Cuerden Lancashire

WSP Transport Assessment Review No.2

Client: Brookhouse Group Job No: J3250954

Date: 21 February 2023 File Name: TN06 v1.0

Figure 1.1: Spine Road into Brookhouse Land (source: WSP Drawing 84465-WSP-XX-DR-005)

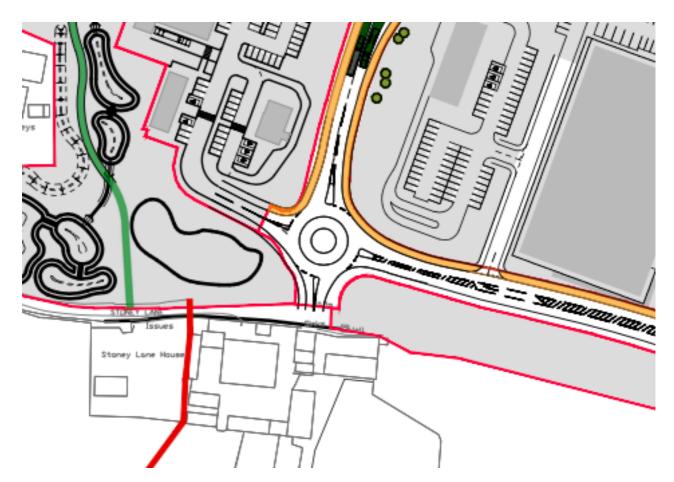
1.2.5 It would appear from the updated drawings that the internal spine road connecting from the north (Zone A) into the Future Phase central parcel of land owned by Brookhouse, has now been provided. As shown in Figure 1.1, WSP's Highways Layout Drawings (1 of 3), the new spine road is now shown to cross over the redline boundary into the central Future Phase plot which it did not do in the previous revisions. This, in addition to the points raised in the covering letter by Barton Willmore, suggested the removal of any potential ransom strip on this Future Phase; an extremely important point which needs to be confirmed within the conditions/ legal agreements to ensure the whole allocation is not prevented from being delivered.

1.2.6 Whilst the connection from Zone A is positive in terms of the Future Phase delivery, the access onto Stanfield Lane now being submitted in detail/ full does not include a link road through Zone D into the central Future Phase plot. This means that the complete through route between M65 Terminus and Stanifield Lane cannot be provided by Brookhouse as part of their future phase and relies on further discussion with the applicant to provide the connection into Zone D, potentially preventing the delivery of the through route.
